**ADDENDUM  
NO. 02**

**March 14, 2022**

**Warren Central High School Phase 3 Renovation and Addition  
9500 E. 16<sup>th</sup> Street  
Indianapolis, IN 46229**

This Addendum consists of Pages ADD 2-1 through ADD 2- 5, and attached CSO Architects Addendum No. 2 , dated March 13, 2023, consisting of 11 Pages, Specification Section 02 01 00 – Maintenance of Existing Conditions, and Addendum 2 Drawings: C101, C102, C401, C501, C502, C503, LD001, L101, L106, L201, L206, L301, L306, S201PRT, S202PRT, S501, S601, AD201N, A201M, A201N, A202N, A211G, A211M, A211N, A401, A404, A423, A431, A432, A600, A601, A602, A603, A611, A612, A701, A702, A703, A800, A801F, A801J, A801M, A801N, A801P, A801R, A801T, A802F, A802N, A802P, A802R, A802T, A900A, A900B, A901K, A902U, A903, A904, A905, A906, MD201F, MD201H, MD201J, MD201K, MD201L, MD202HJ, MD202N, M201F, M201J, M201K, M201L, M201N, M202HJ, M202N, M211F, M211H, M211J, M211K, M211L, M211N, M212HJ, M301, M303.

3.25 SHEET A401 – PARTIAL BUILDING SECTIONS

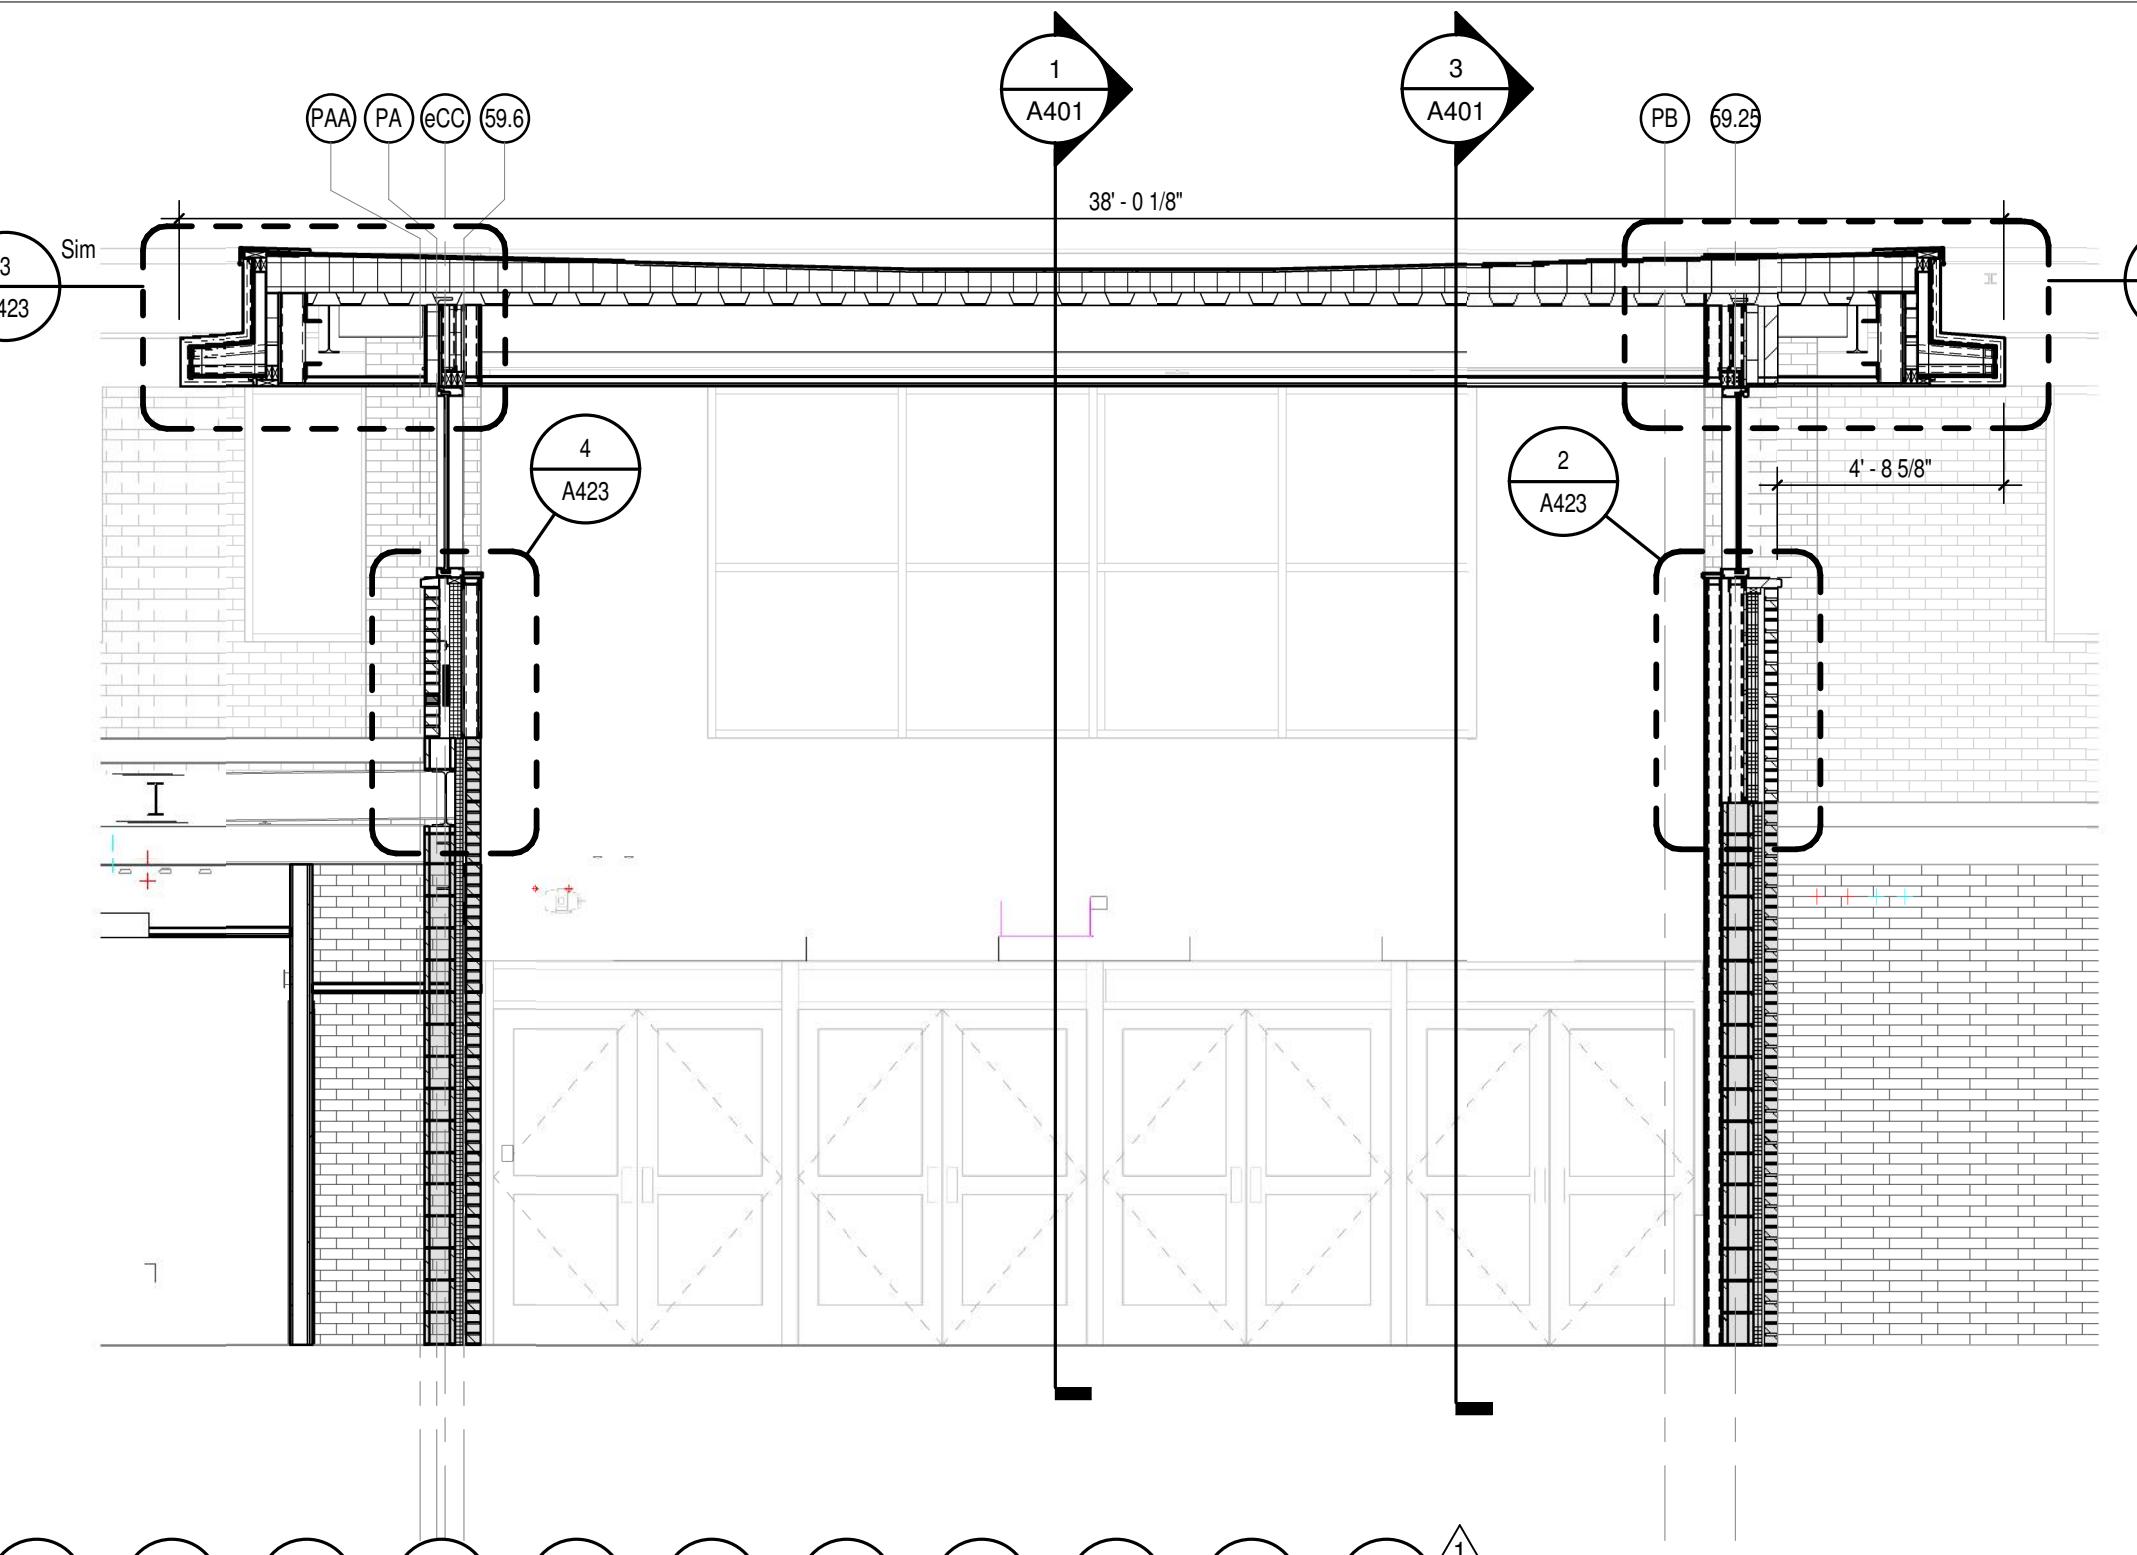
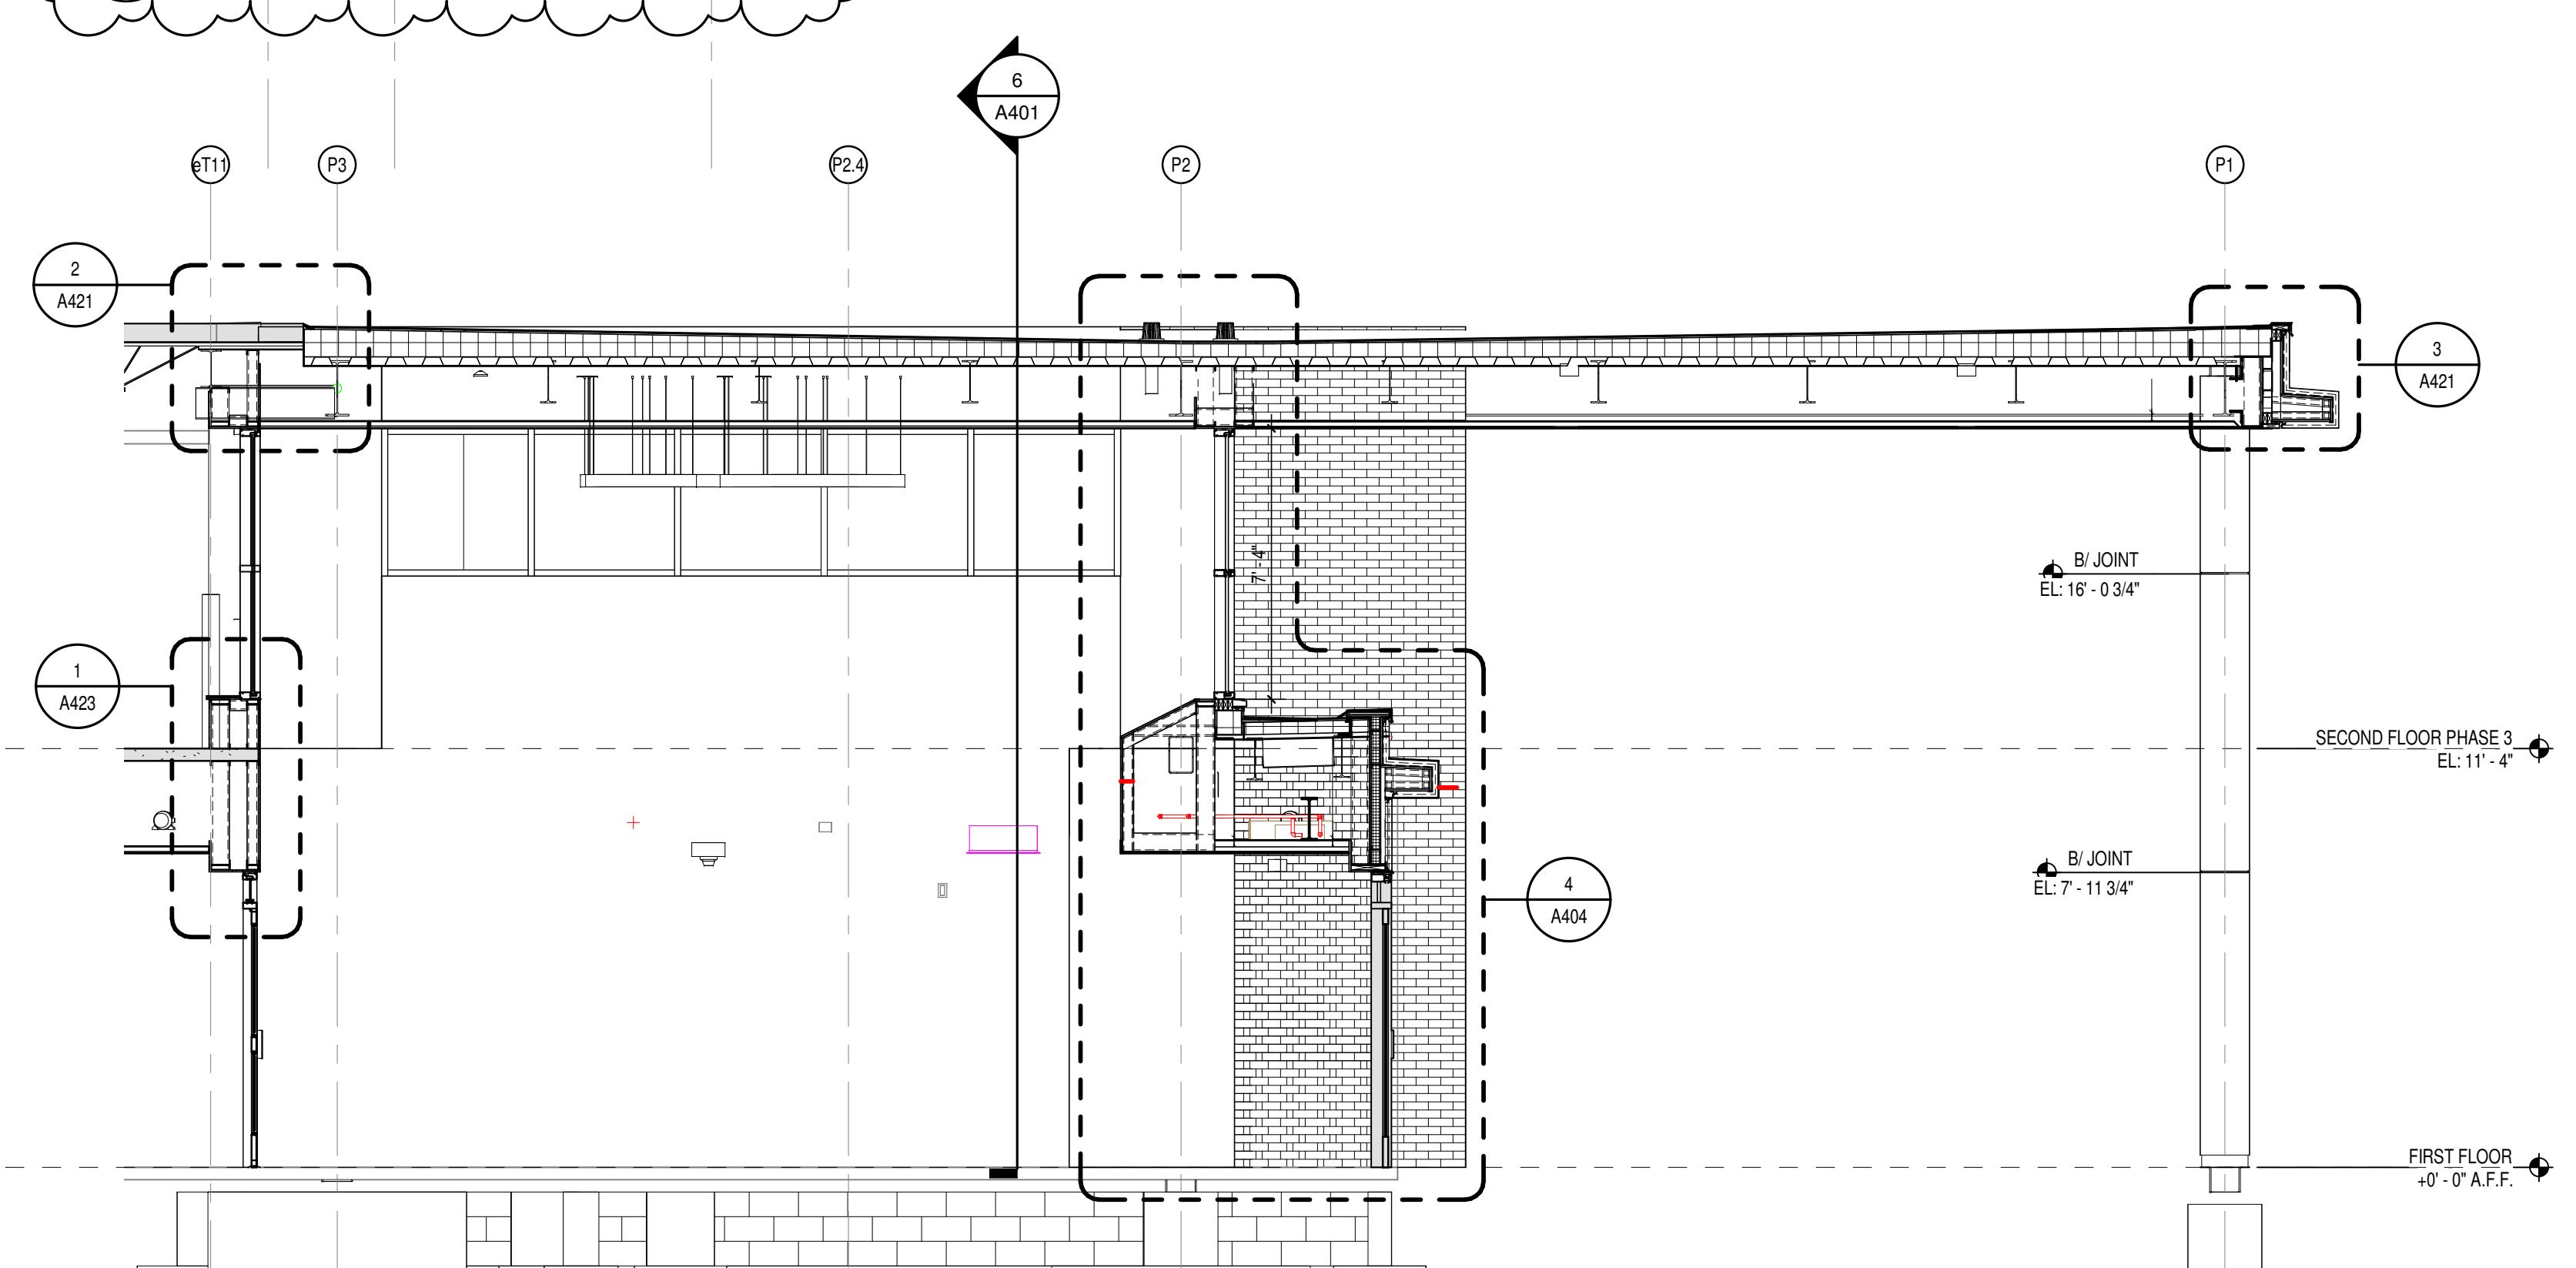
- A. REVISE section 1 as indicated on attached, re-issued Sheet A401
- B. ADD sections 3 and 6 as indicated on attached Sheet.

4  
A404 ALTERNATE VESTIBULE WALL SECT  
SCALE: 3/4" = 1'-0"

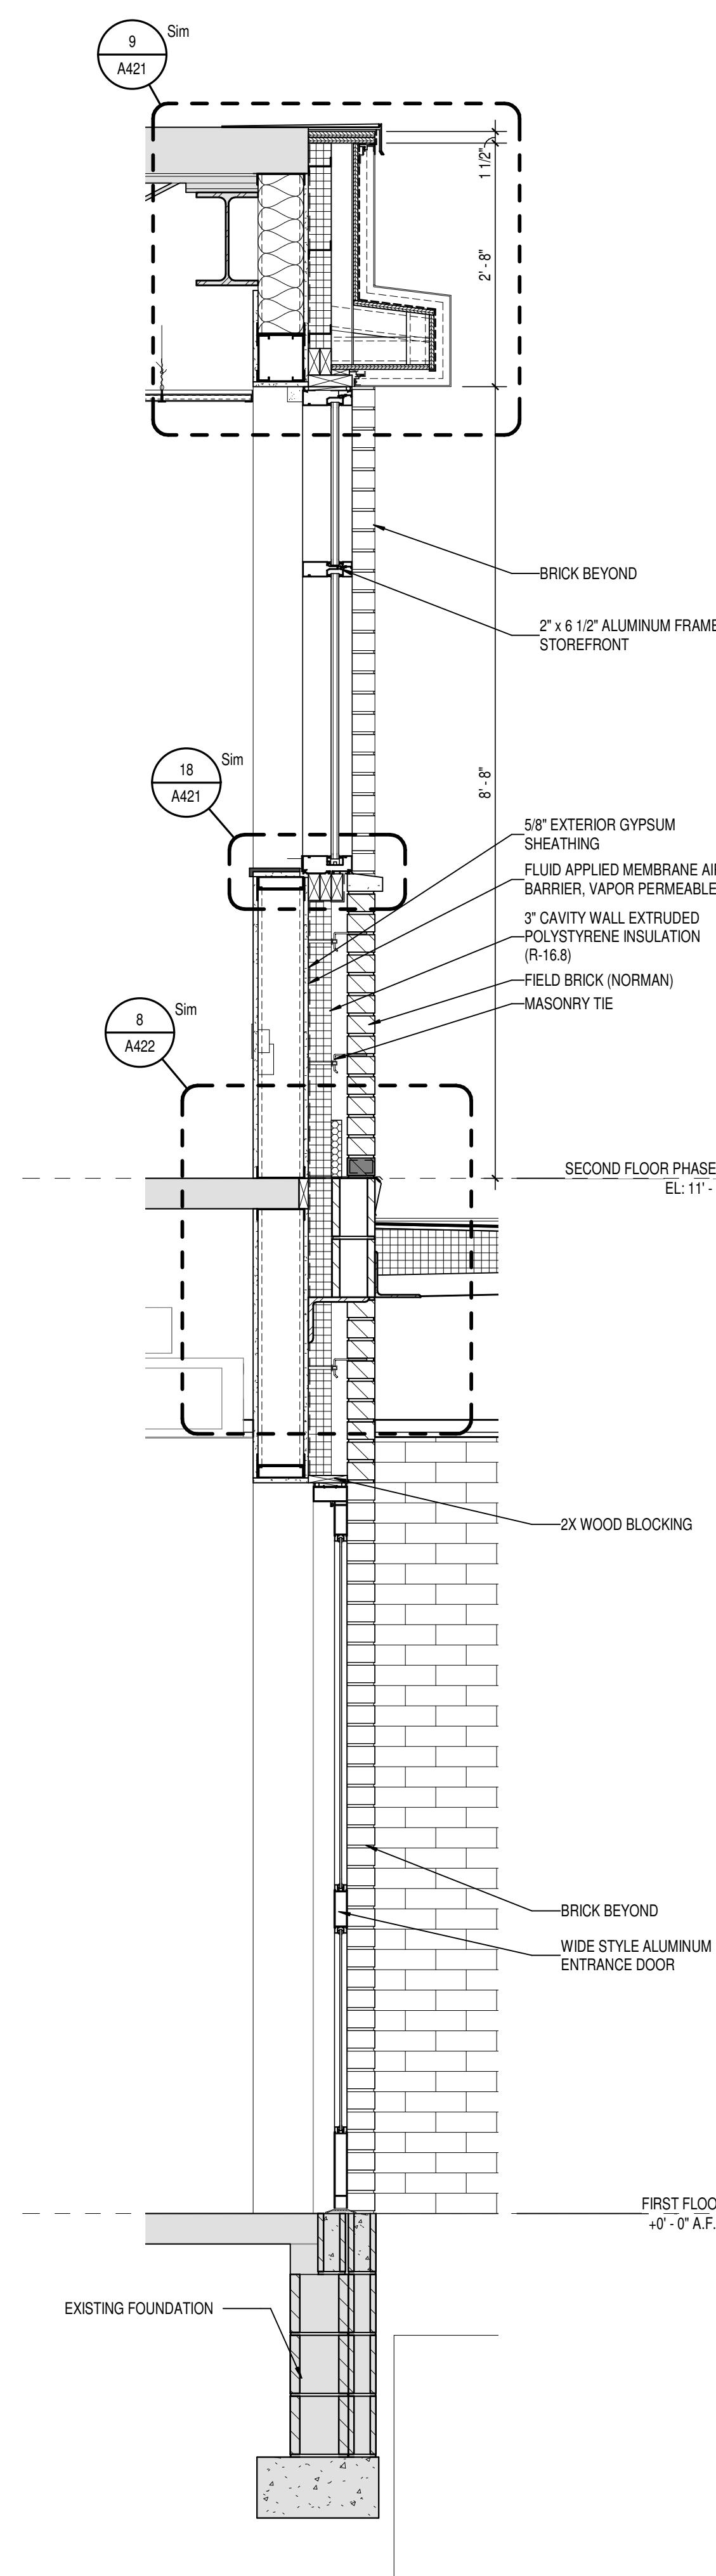
- A. REVISE section 4 as indicated on attached, re-issued Sheet. A404.
